ROADWAY LAYOUT I

PROJECT NAME:	BRANDON	FILE NAME:	zb008s5-gen01.dgn	PLOT DATE:	9/3/2009
PROJECT NUMBER:	NH 019-3(495)	PROJECT LEADER:	CRB	DRAWN BY:	NLL
		DESIGNED BY:	DAM	CHECKED BY:	PTS
		CLD 02-0149		SHEET	68 OF 546

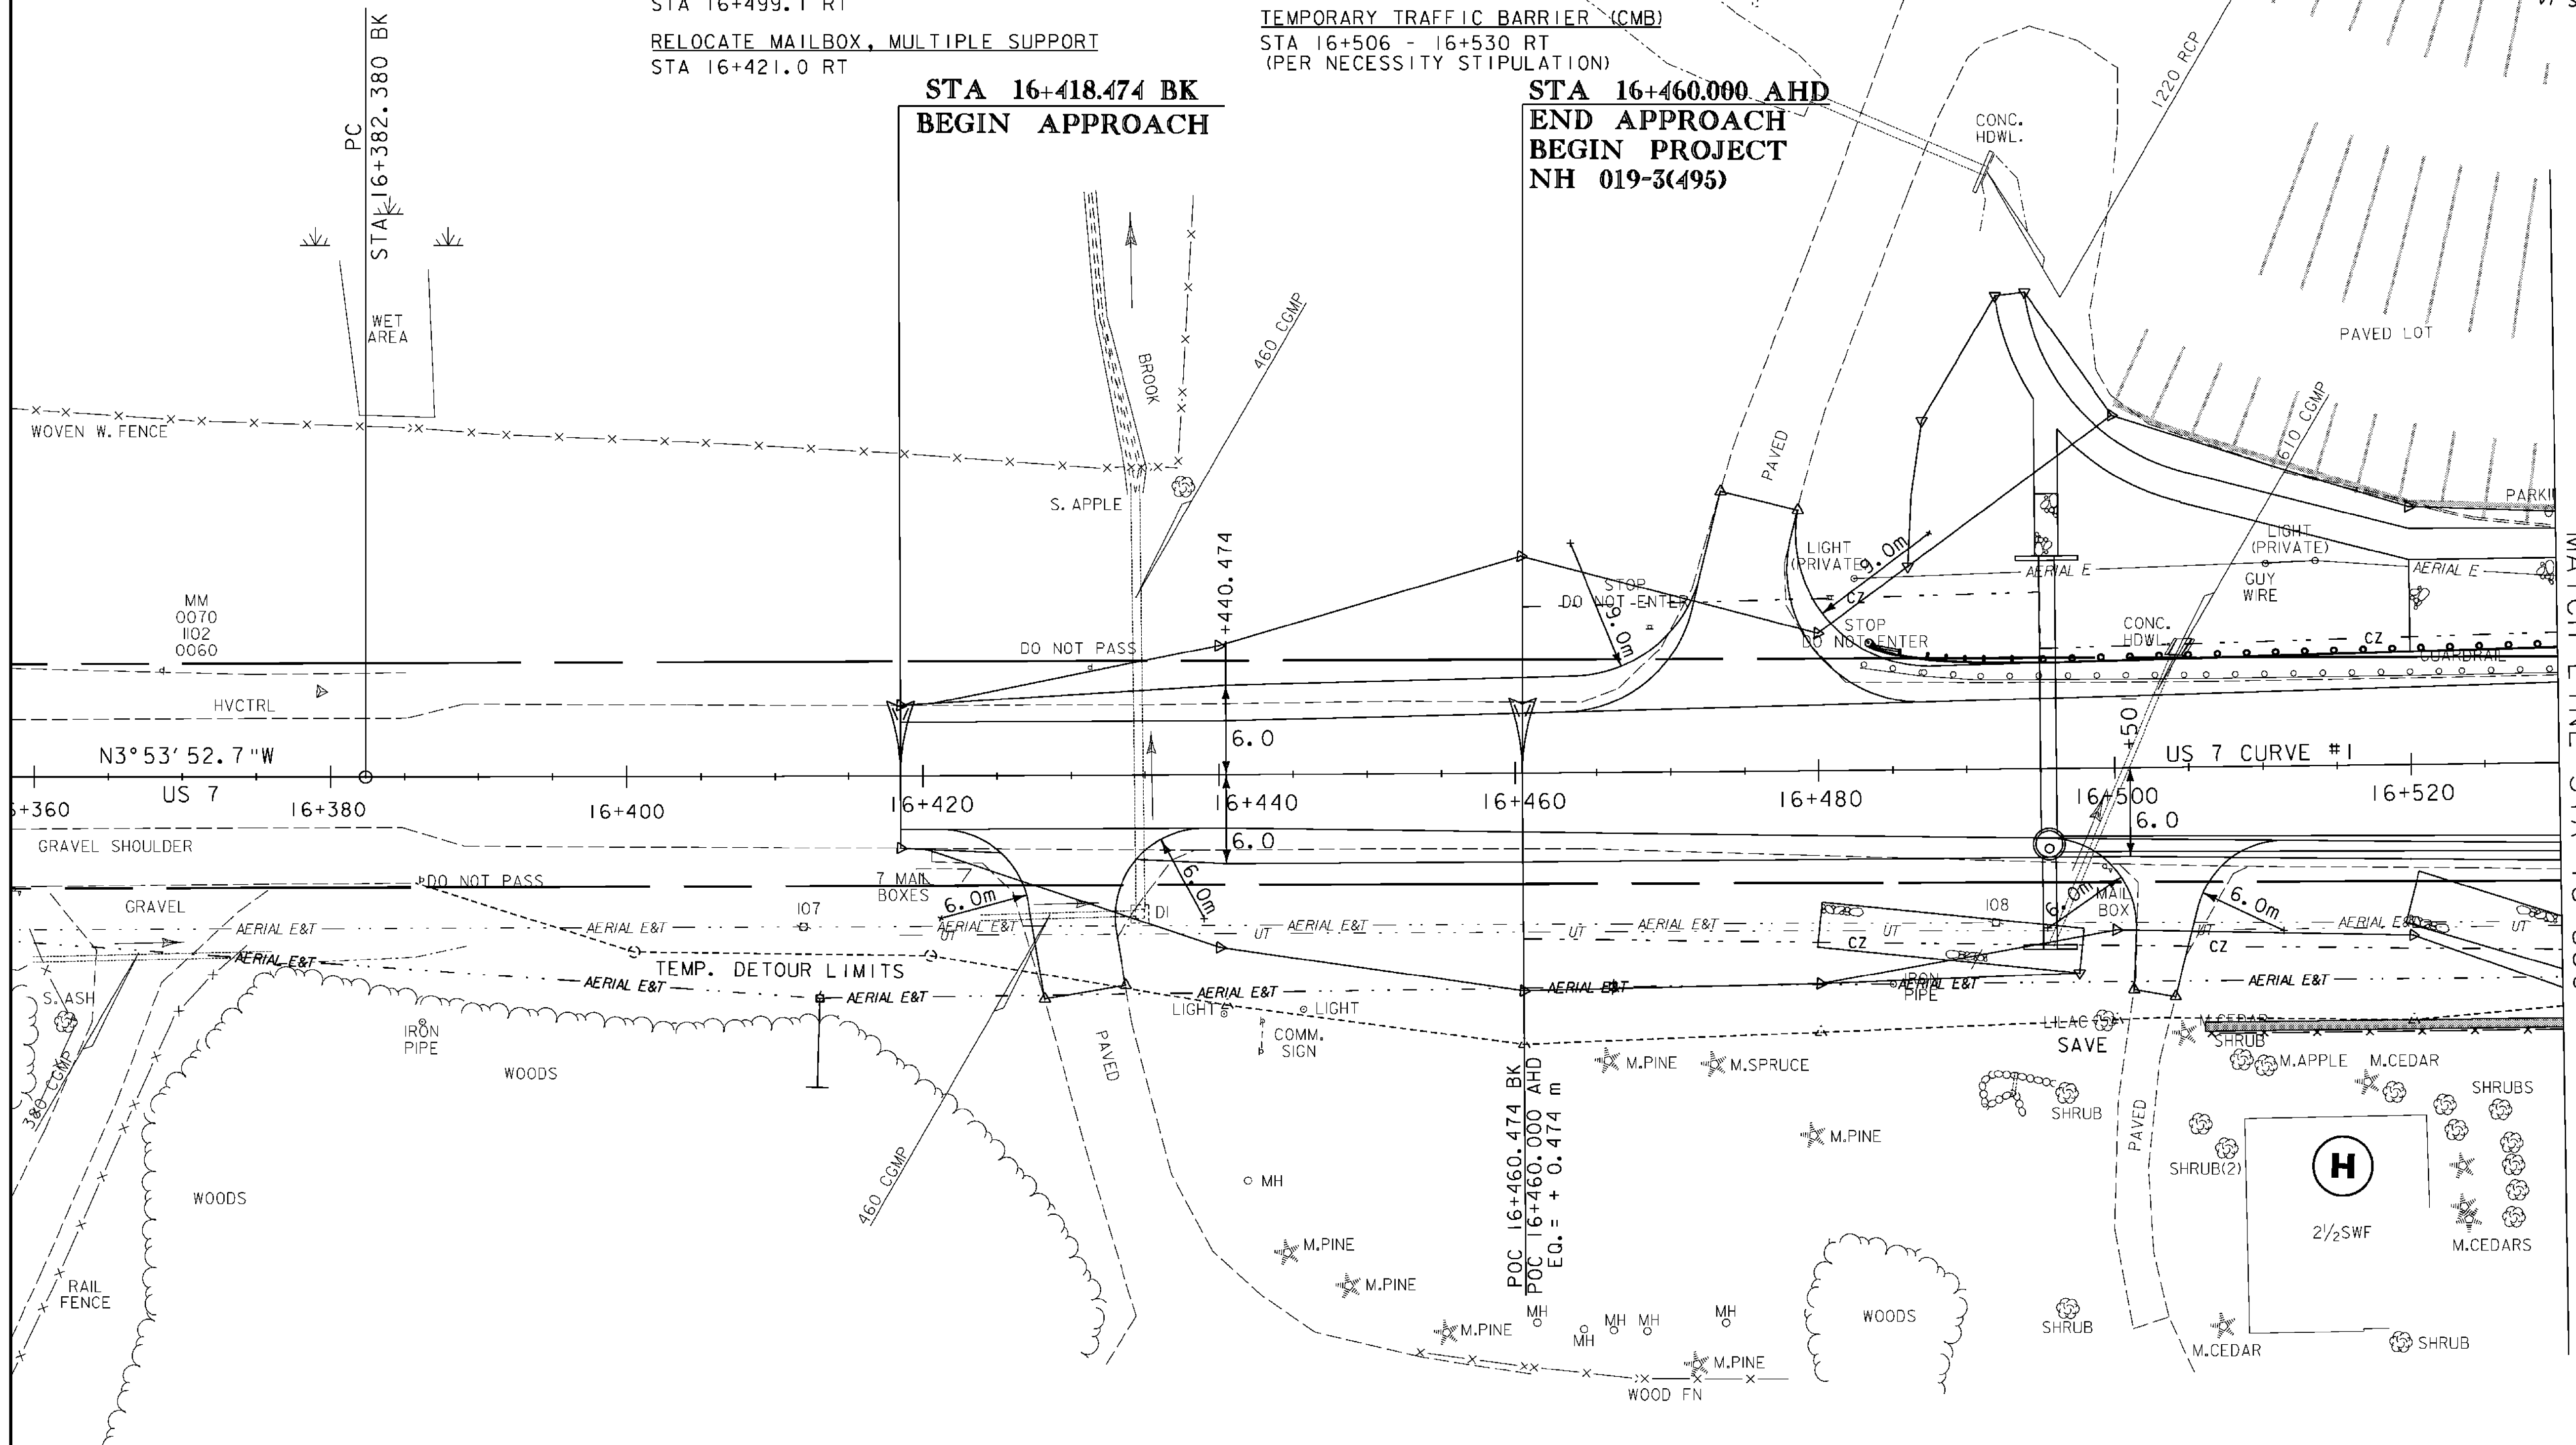
~~STA 16+482.5 LT (WORK DONE BY SCHOOL)~~
~~STA 16+513.7 LT~~

~~STA 16+440.2 RT (LIGHTS NOT THERE)~~
~~STA 16+445.6 RT~~
